CITY OF WEST LAKE HILLS, TEXAS
NOTICE OF ZONING & PLANNING COMMISSION (ZAPCO) REGULAR MEETING
Wednesday, April 16, 2025 at 6:30 PM

MINUTES OF A ZONING & PLANNING COMMISSION (ZAPCO)

DRAWING NO.:
1267-001-TOPC

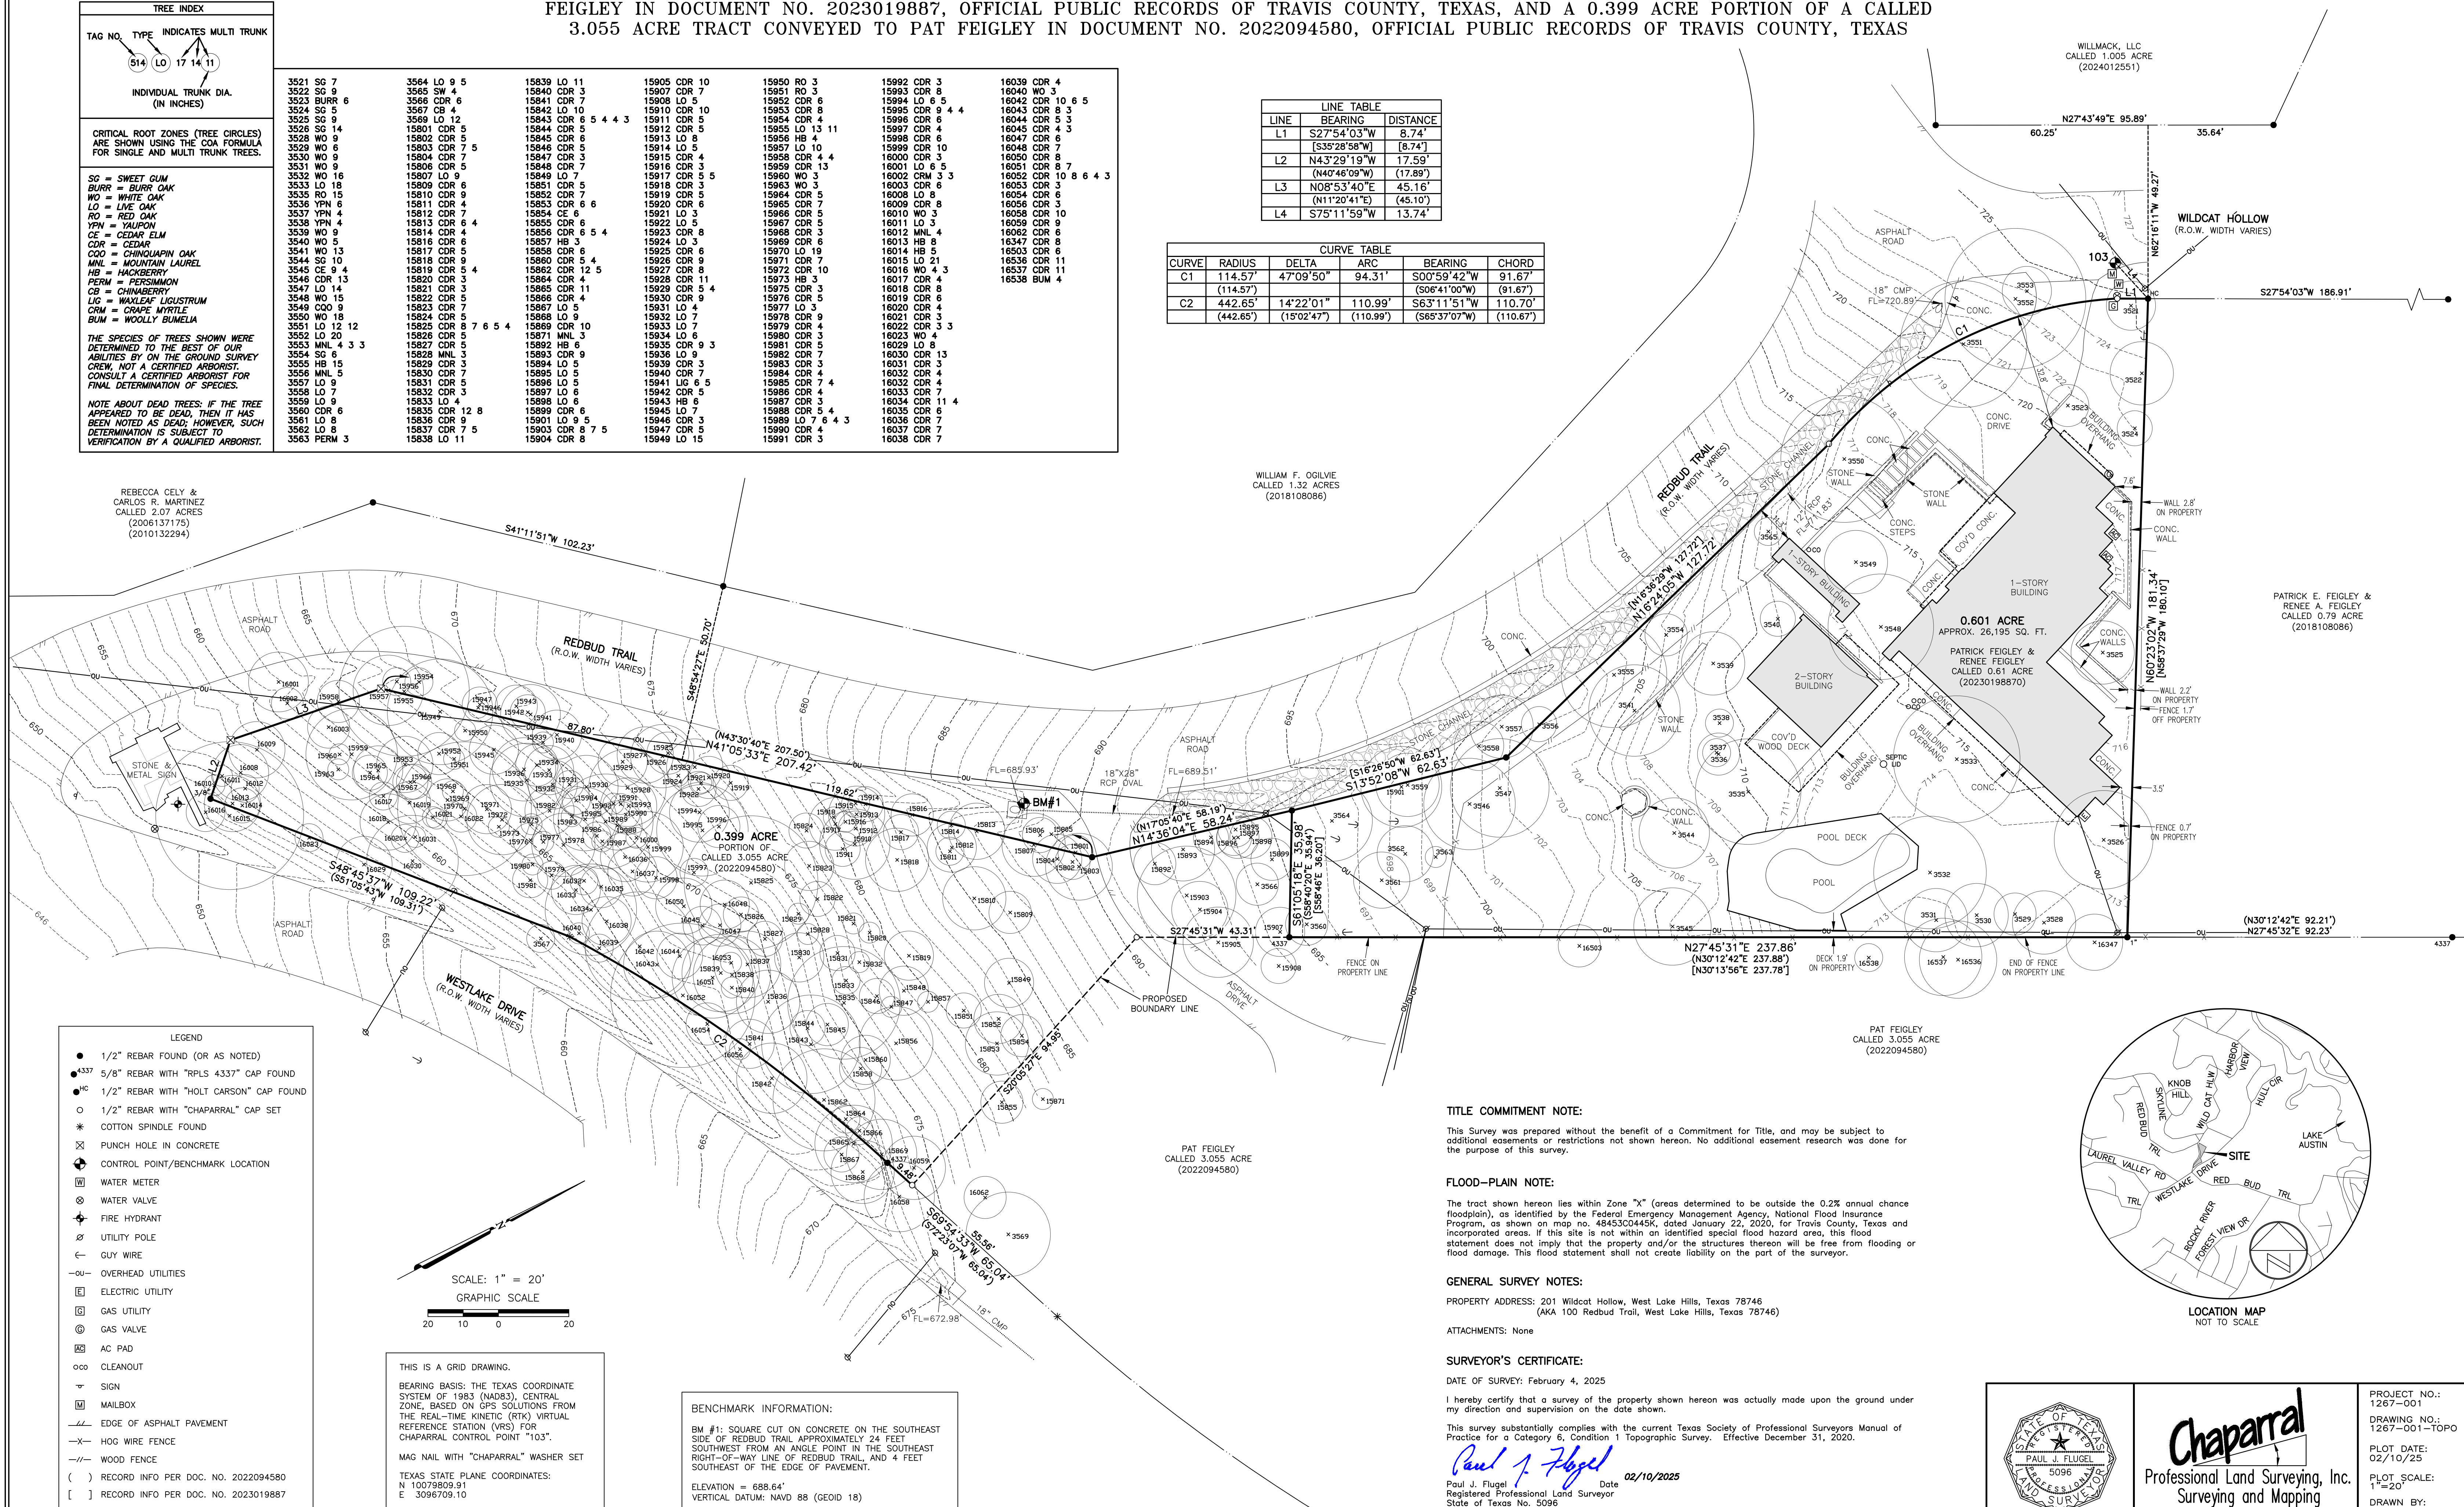
1. Provide address for owner/subdivider (Plat Details 1).
2. Change the name to 201 Wildcat Minor Plat, or propose a name that does not conflict with other recorded plats (Plat Details 2).

3. Add Minor Plat to the title (Section 36.01.018).
4. Required right-of-way for Redbud Trail 500 feet from Westlake Drive is 70 feet. Show the dedication of the balance of half of the remaining ROW ((70-existing)/2) (Section 36.01.009, Table 36-2 Street Design Standards).

5. Remove one of the Lot 1 labels (only one label per lot) (Plat Detail 13).
6. Show that lot meets one acre minimum after right-of-way dedication (Plat Detail 17).

7. Submit deed restrictions, conditions and covenants applicable to the land (Plat Detail 20).
8. Add the following signature blocks/certification:
Zoning & Planning Commission, City Council, City Administrator, Water Control and Improvement District No. 10, Oak Wilt Certification, remove duplicate Travis County Certification Block (Plat Detail 24 and Signature Blocks)
OAK WILT CERTIFICATION
I, the undersigned, a certified arborist hereby certify that oak wilt was not found on the property.

9. Streets to be dedicated, add complete curve data on side dedicated (Plat Detail 27).
10. Add the following plat notes 2, 3, 4, 32(Subdivision Checklist, Section 3).

REPLAT OF S. 49' OF LOT 3 & N. 35' OF LOT 4
RIDGEWOOD VILLAGE, SEC. 2 SUBDIVISION

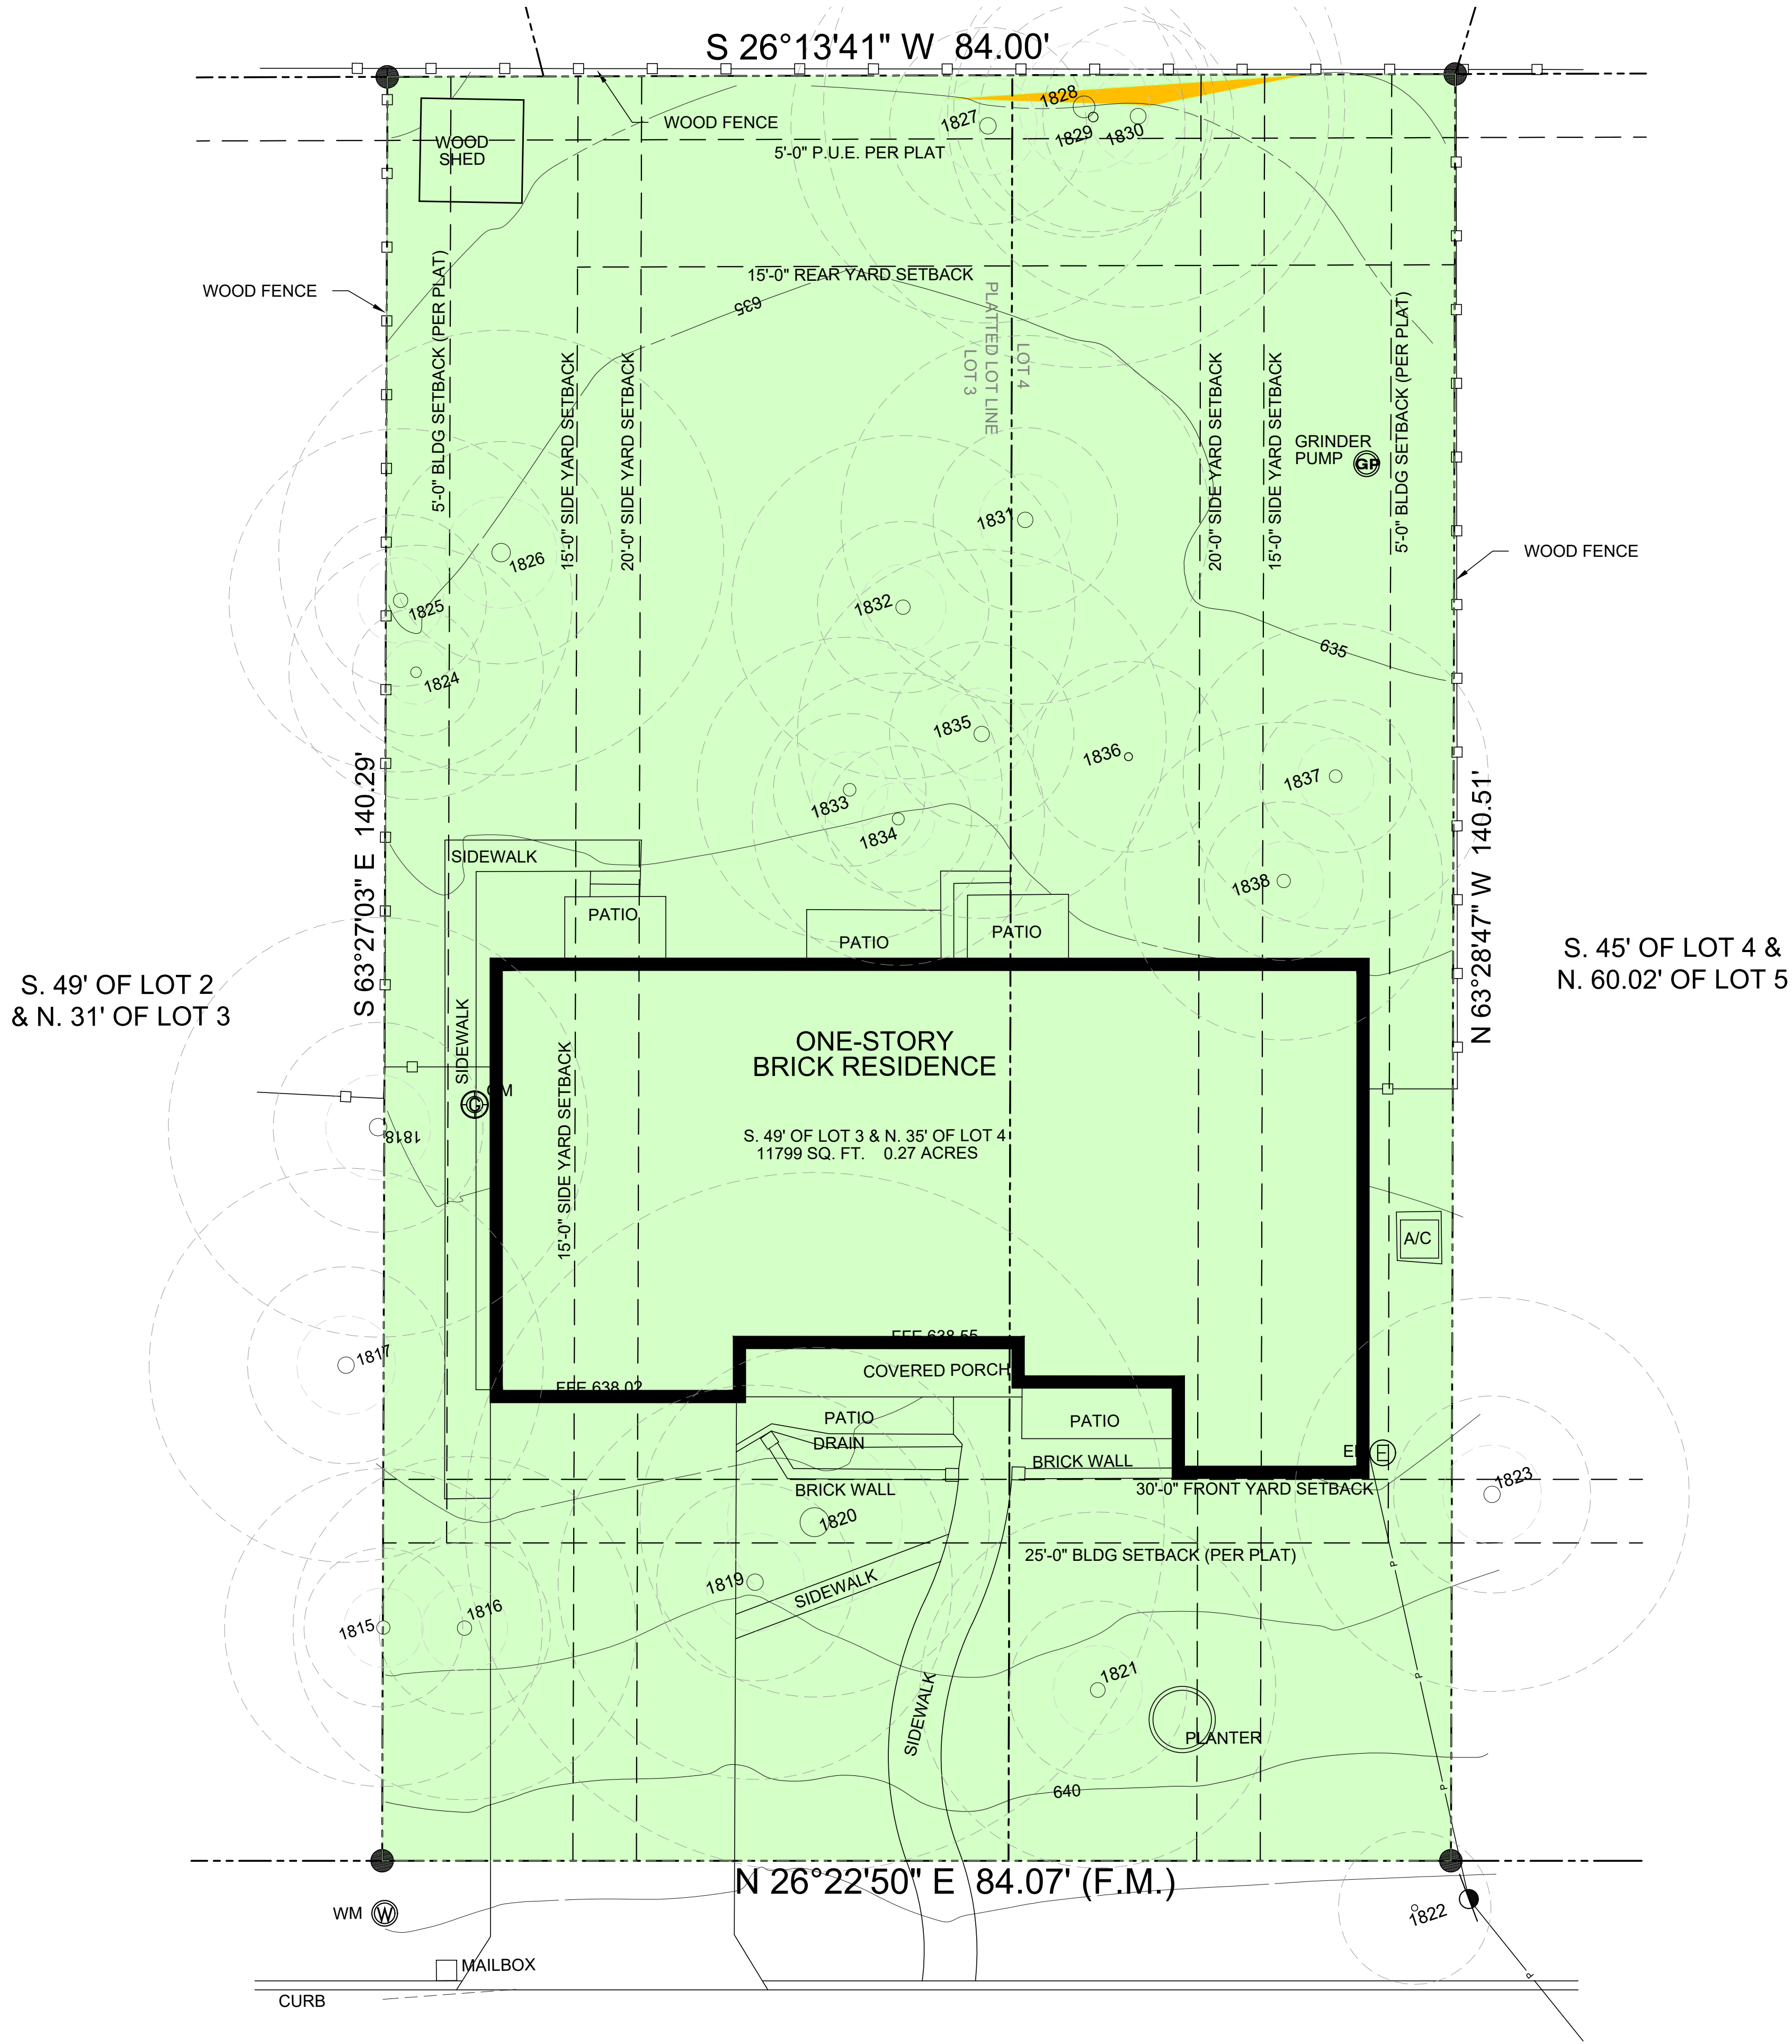
1. Change the plat title to Lot 3R, a replat of portions of Lot 3 and 4 of Ridgewood Village Section 2 Subdivision. Correct the word "survey" below the title. Change in title and owners' dedication block. Plat detail 2.
2. Provide any restrictive covenants, deed restrictions for the properties, that are referenced in the survey provided and include reference on plat (application materials O, Plat Details 20, Plat Note 32)
3. Reduce vicinity map to one square mile and show West Lake Hills city limits (Plat Details Item 15)
4. Provide certification blocks for signature by applicant's/owner's professional:
No presence of Oak Wilt Plat Detail 24

5. Add the following plat notes (Checklist Section 3 Standard Plat Notes): 1 2, 3, 4, 6, 11, 12, 14, 18, 20, 21, 24, 28, 30, 32

PLATE STEEL WALL / PEDESTRIAN GATE

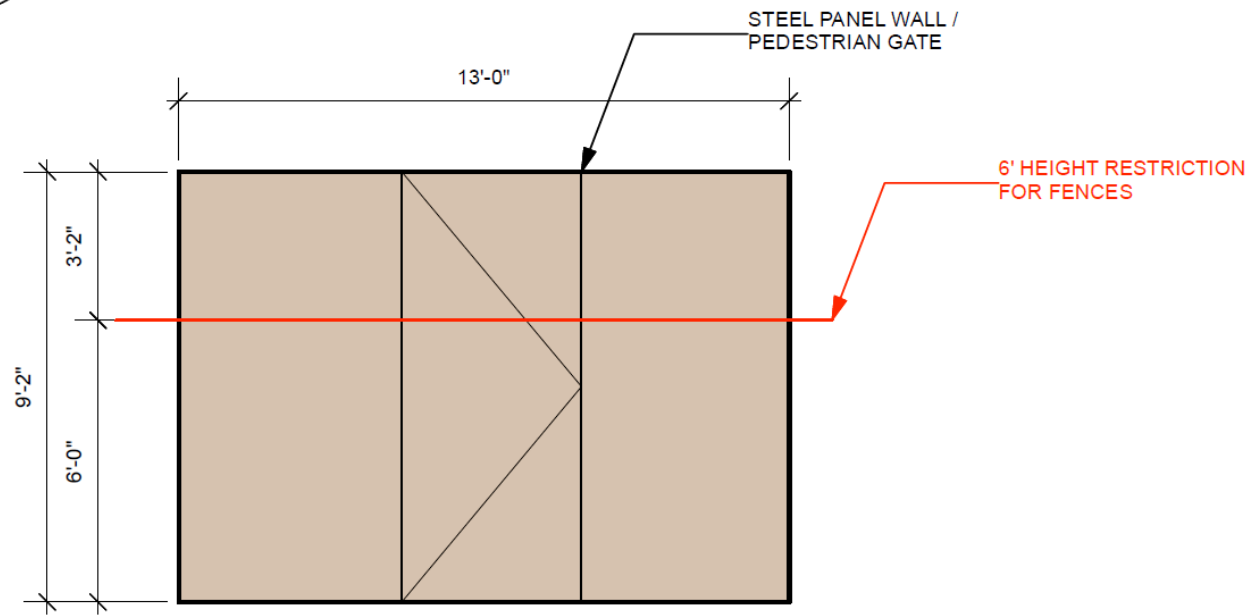
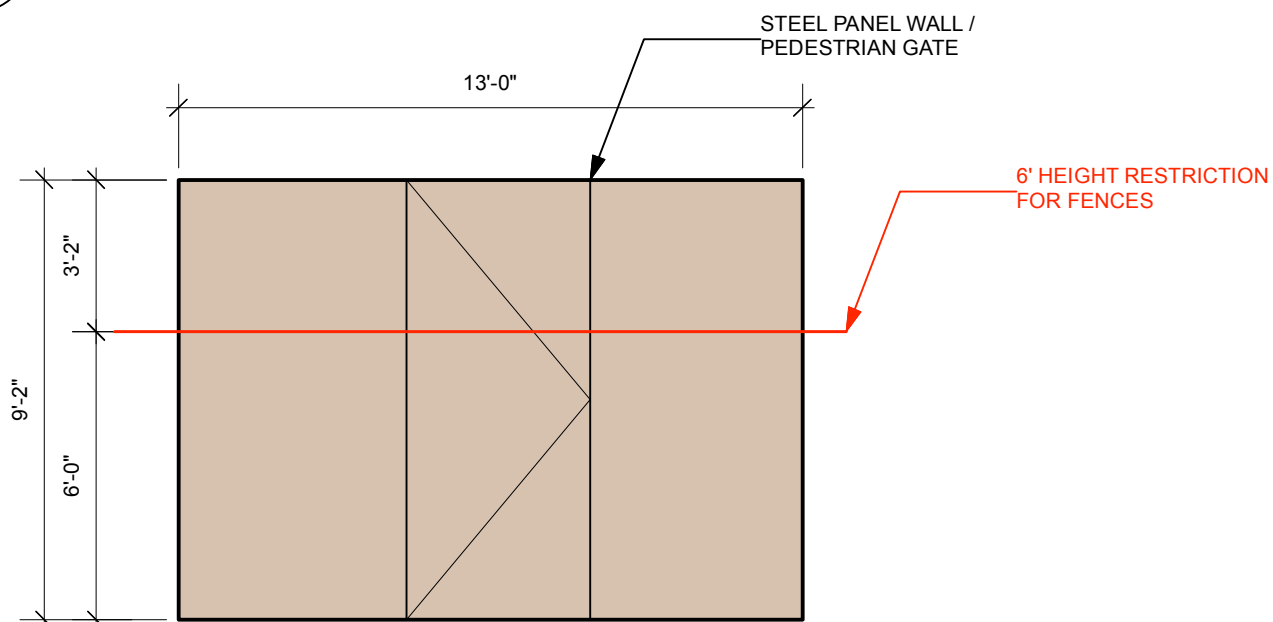
The fence is located on the property line in a lot of locations, which at the smallest distance, encroaches 25.5 feet in the required 30-foot front yard fence setback. The red area below indicates the area between the fence and the 30 foot setback.

This area leads to a stairway entrance for the property. The length of the solid fencing is 13 feet out of over 350 feet of street frontage, which is a minimal disruption to the visibility.
